SURRY POWER STATION, UNIT NO. 1

AMENDMENT TO FACILITY OPERATING LICENSE

Amendment No. 207
License No. DPR-32

SURRY POWER STATION, UNIT NO. 2

Surry Units 1 and 2 Reactor Coolant System Heatup Limitations (Heatup Rates up to 60 F/hr) Applicable for the First 28.8 EFPY for Surry Unit 1 and the First 29.4 EFPY for Surry Unit 2

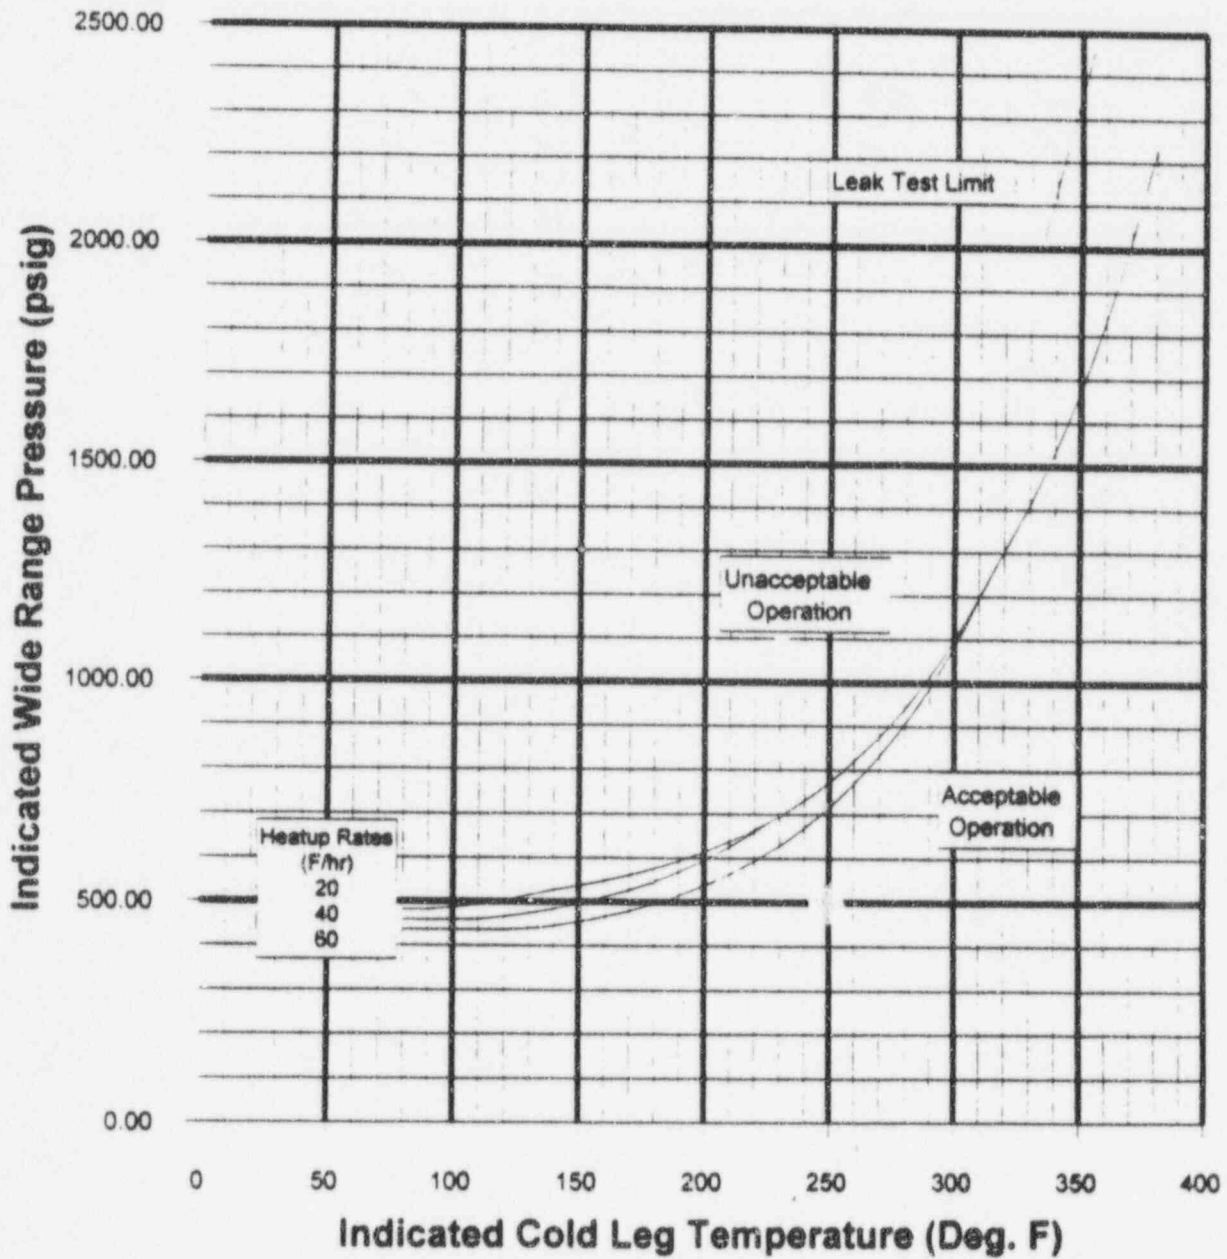
1. Unit 1 and Unit 2 reactor coolant temperature and pressure and the system heatup and cooldown (with the exception of the pressurizer) shall be limited in accordance with TS Figures 3.1-1 and 3.1-2.

Figure 3.1-1 may be used for heatup rates of up to 60°F/hr.

The heatup limit curve, Figure 3.1-1, is a composite curve which was prepared by determining the most conservative case, with either the inside or outside wall controlling, for any heatup rate up to 60°F per hour. The cooldown limit curves of Figure 3.1-2 are composite curves which were prepared based upon the same type analysis with the exception that the controlling location is always the inside wall where the cooldown thermal gradients tend to produce tensile stresses while producing compressive stresses at the outside wall. The cooldown limit curves are valid for cooldown rates up to 100°F/hr. The heatup and cooldown curves were prepared based upon the most limiting value of the predicted adjusted reference temperature at the end of 28.8 EFPY and 29.4 EFPY for Units 1 and 2, respectively. The adjusted reference temperature was calculated using materials properties data from the B&W Owners Group Master Integrated Reactor Vessel Surveillance Program (MIRVSP) documented in the most recent revision to BAW-1543 and reactor vessel neutron fluence data obtained from plant-specific analyses.

Surry Units 1 and 2 Reactor Coolant System Cooldown Limitations (Cooldown Rates up to 100 F/hr) Applicable for the First 28.8 EFPY for Surry Unit 1 and the First 29.4 EFPY for Surry Unit 2

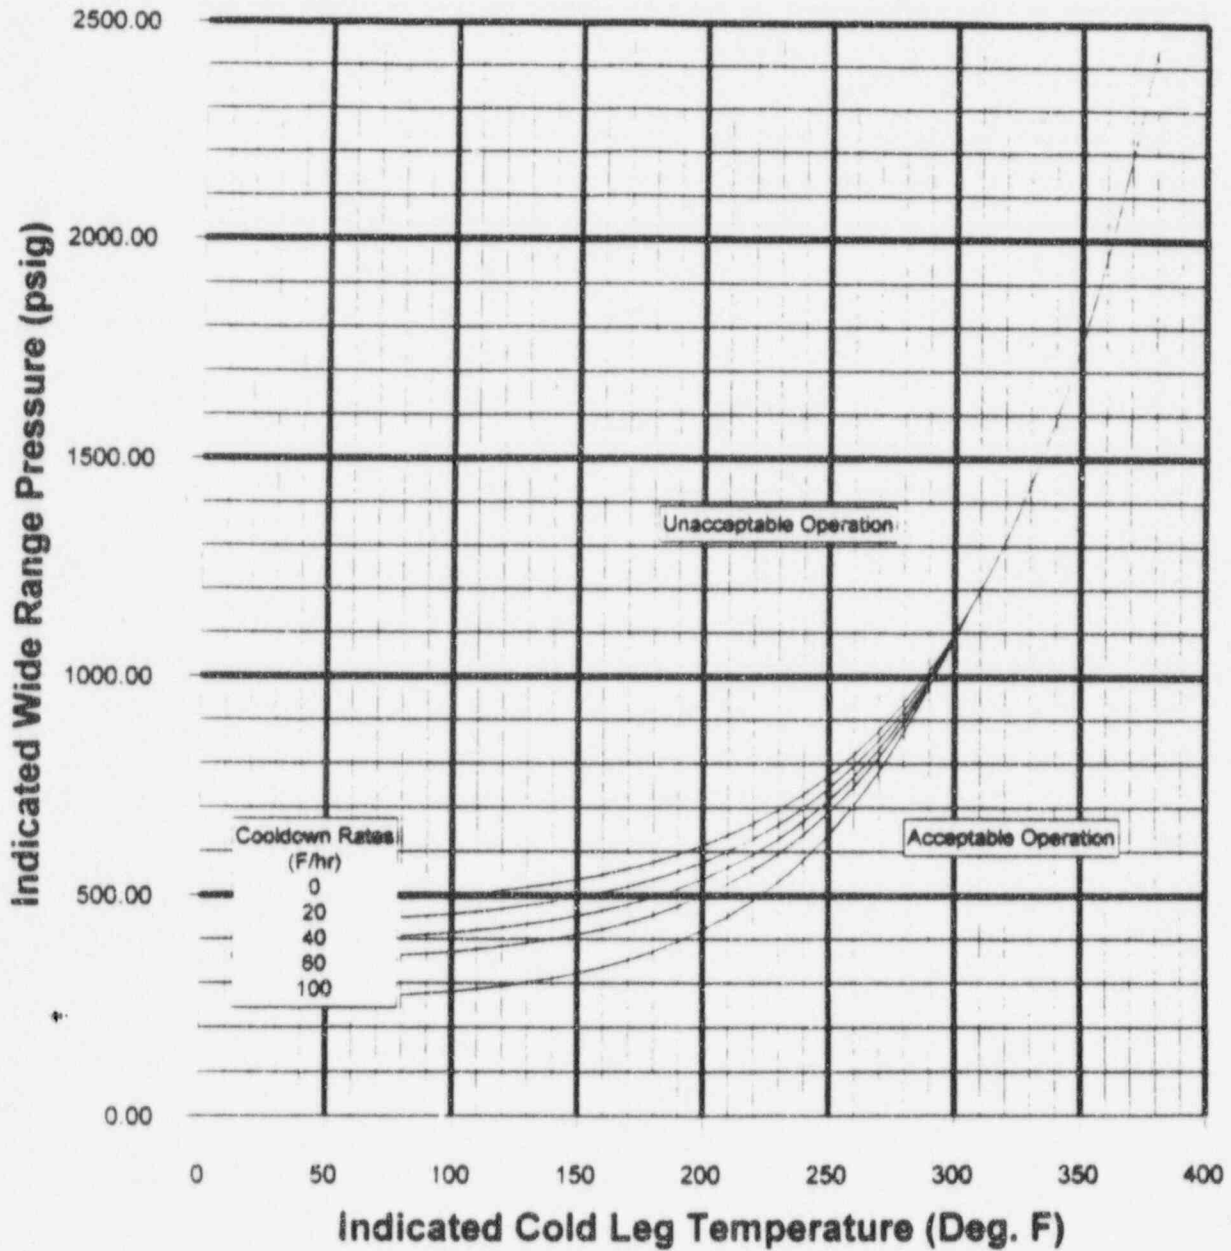
Allowable combinations of pressure and temperature for specific cooldown rates are below and to the right of the limit lines as shown in TS Figure 3.1-2. This rate shall not exceed 100°F/hr. Cooldown rates between those shown can be obtained by interpolation between the curves on Figure 3.1-2.
